Report and Recommendations for El Mirage Drainage Improvement Project

Flood Control District of Maricopa County

REPORT AND RECOMMENDATIONS

El Mirage 1998 CIP Request
For
El Mirage Drainage Project

PRELIMINARY DESIGN OF THE EL MIRAGE DRAINAGE CHANNEL

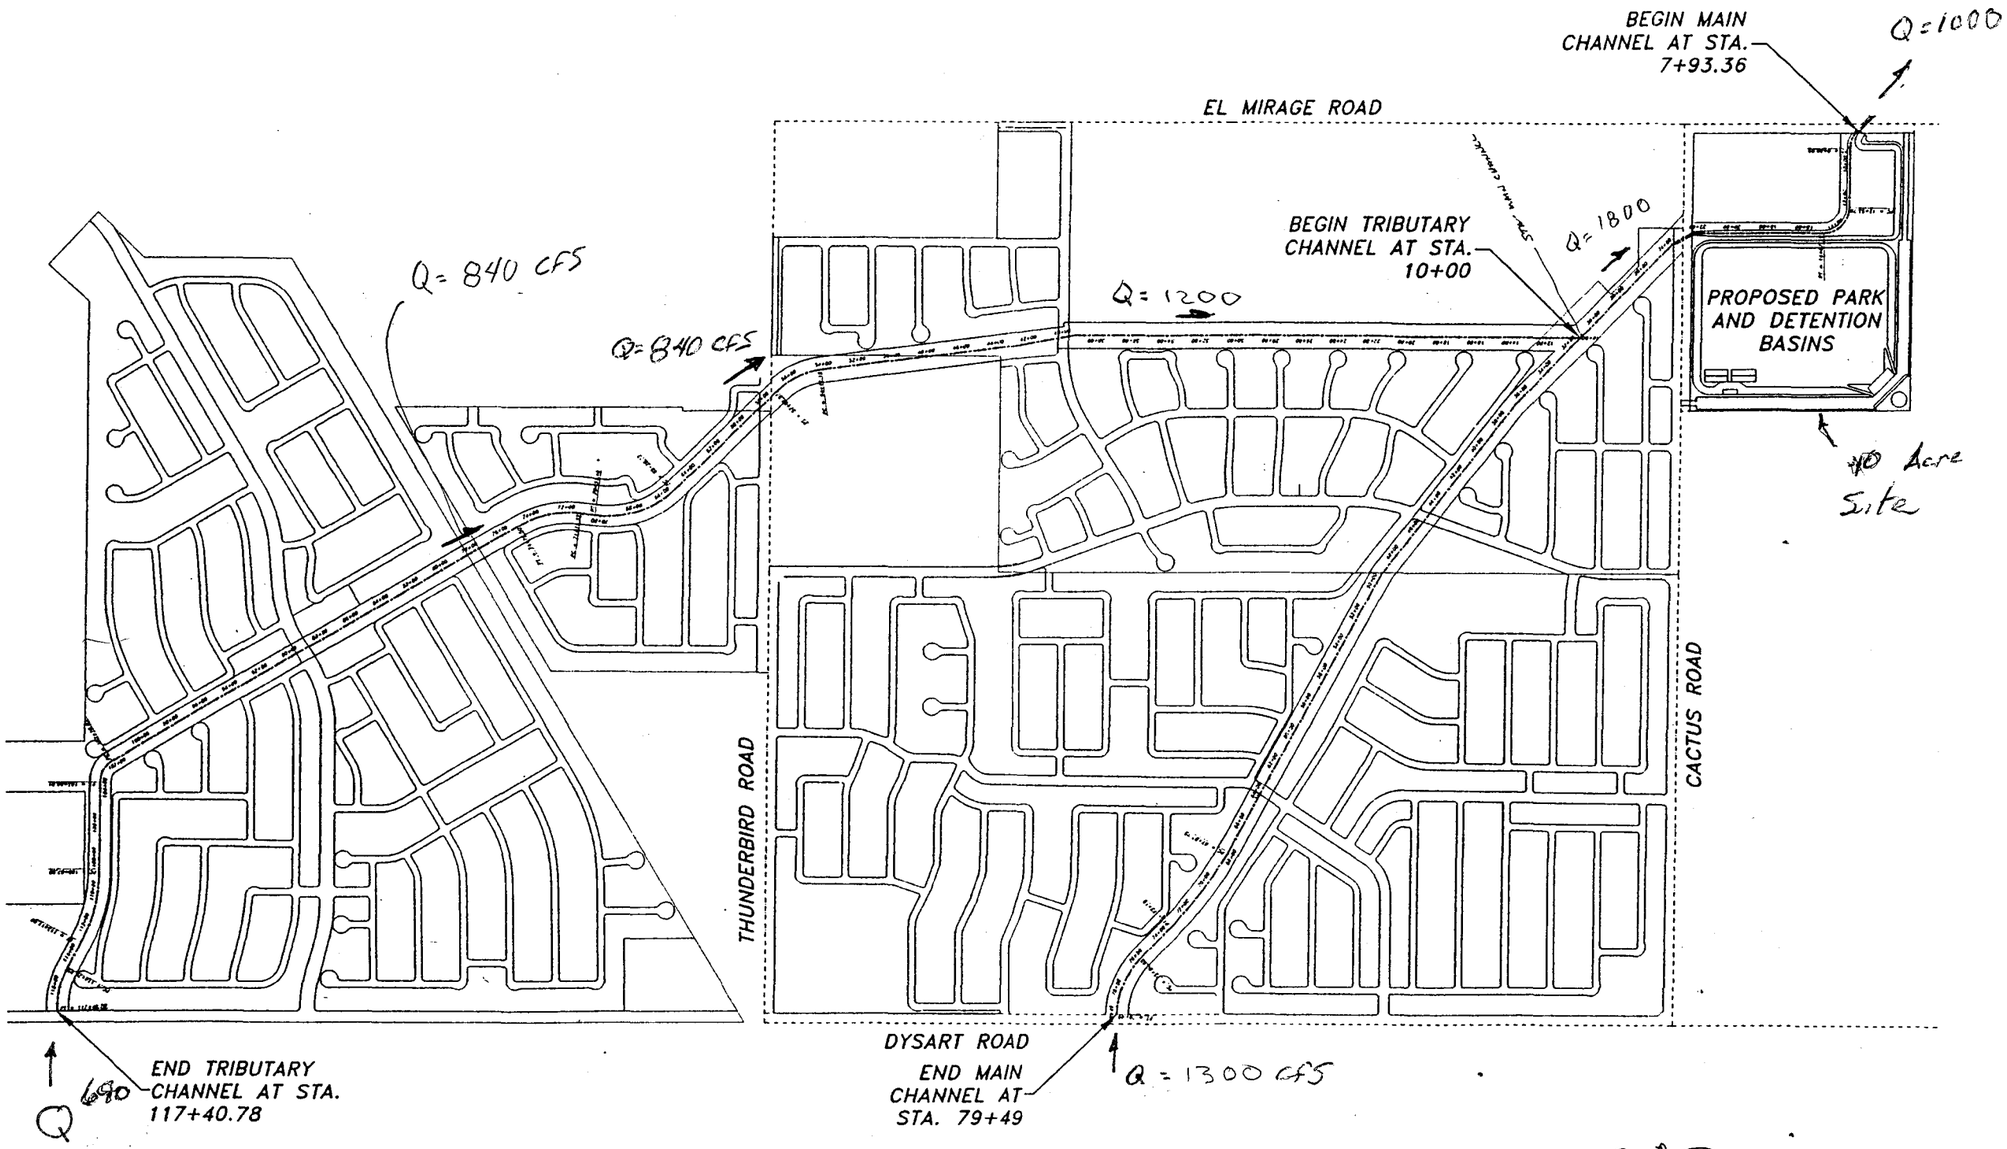
The recommendation of this report is to proceed with the El Mirage Drainage Improvement Project. However, there must be some design issues worked out with the City of El Mirage and the re-evaluate the City' cost estimate share based on the findings of the following issues:

1. Provide the HEC 1 and HEC RAS model to demonstrate that the proposed channel, basin, and the improvements to the El Pueblo Golf Course will handle the 100-year design flows.

2. Provide final Designs and Plans for the project for review and approval by the District.

3. Demonstrate that the first flush issue is addressed.
